MARS HILL BANK OF AMERICA
REMOTE DRIVE UP ATM KIOSK
1685 MARS HILL ROAD
ACWORTH GA 30011

PETITION No.: V-87

TYPE OF VARIANCE: 1) Allow an accessory structure (proposed drive thru ATM) to the front of the principal building; and 2) waive the front setback from the required 50 feet to 15 feet.

COMMENTS

PROPOSED PLAN

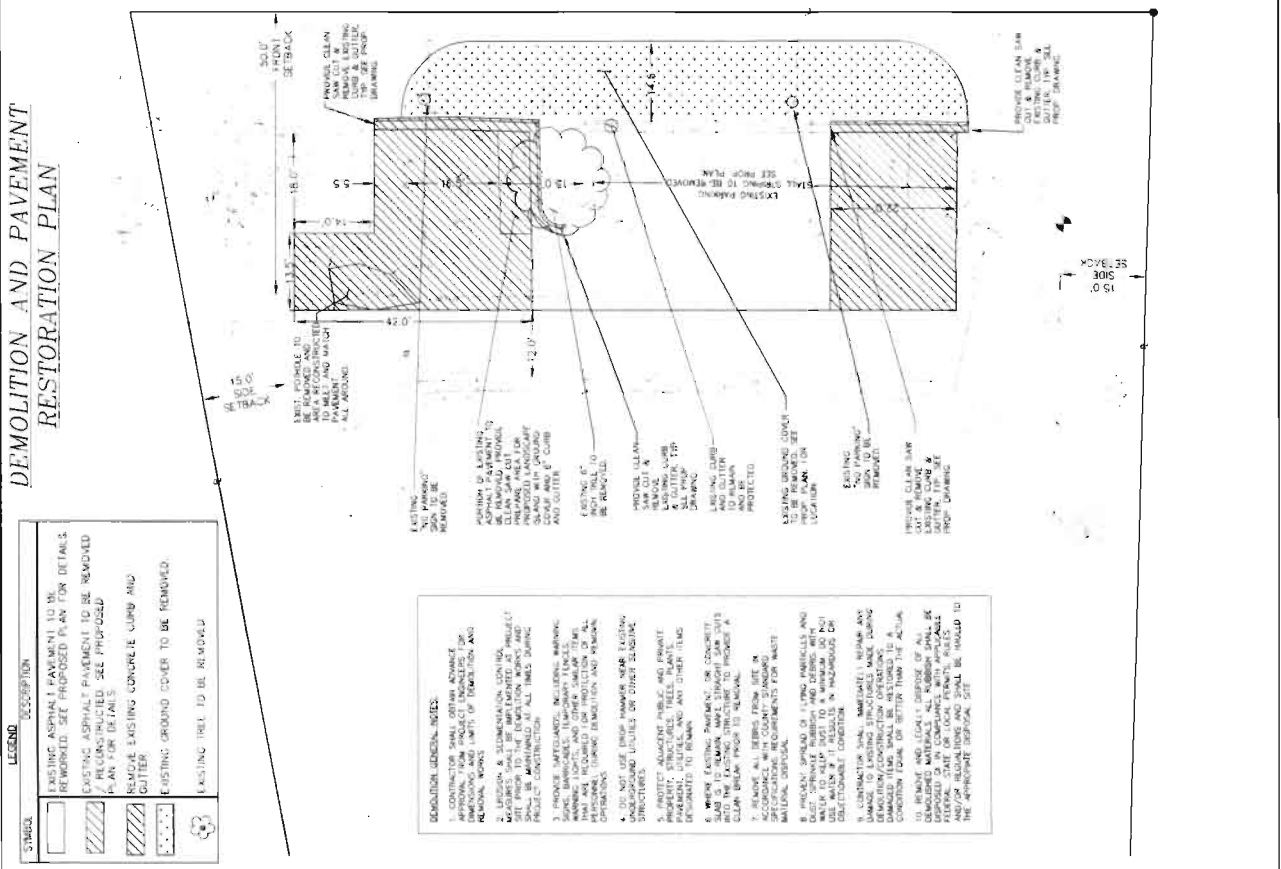
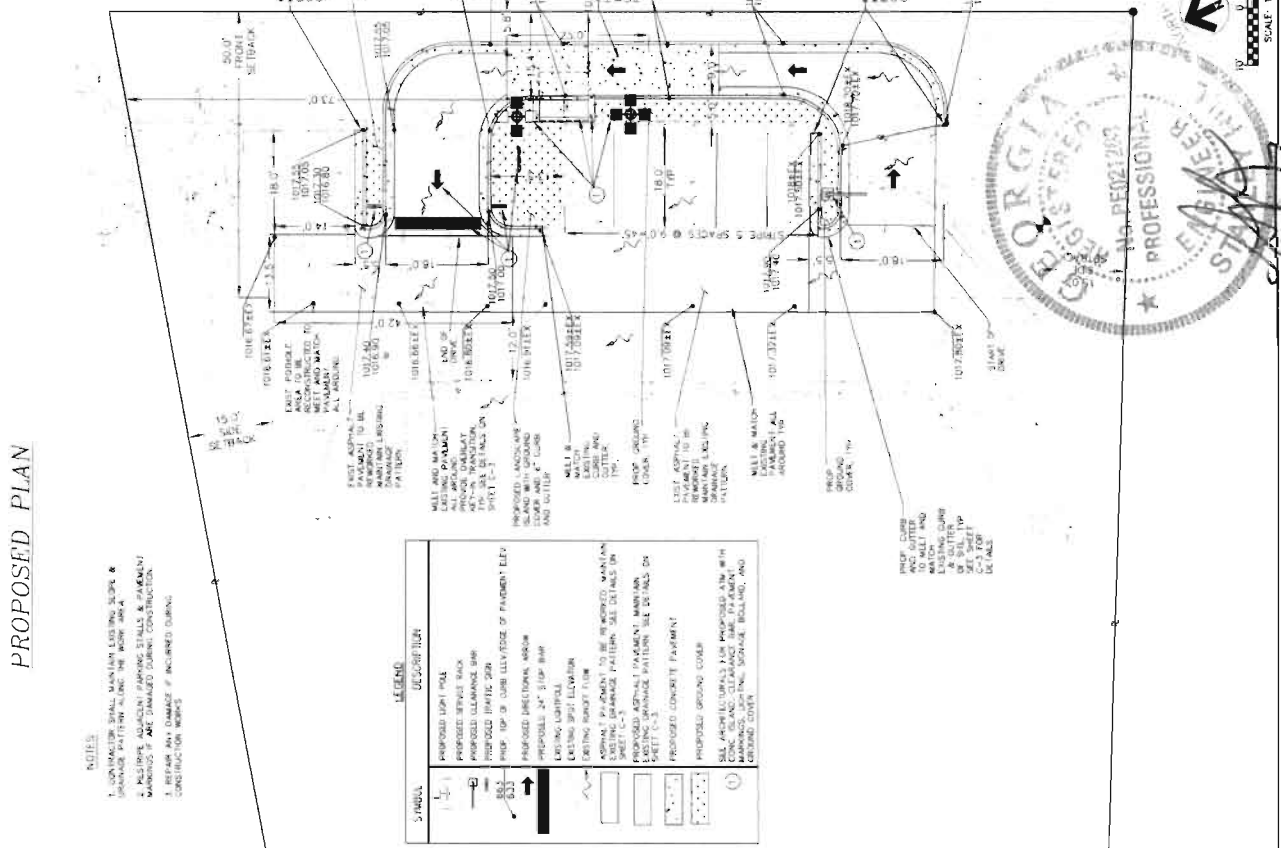
The submitted plan appears to propose the removal of several parking lot trees which were originally installed in order to satisfy Cobb County Tree Ordinance Requirements. Mitigation for the removal of these trees will be resolved during plan review.
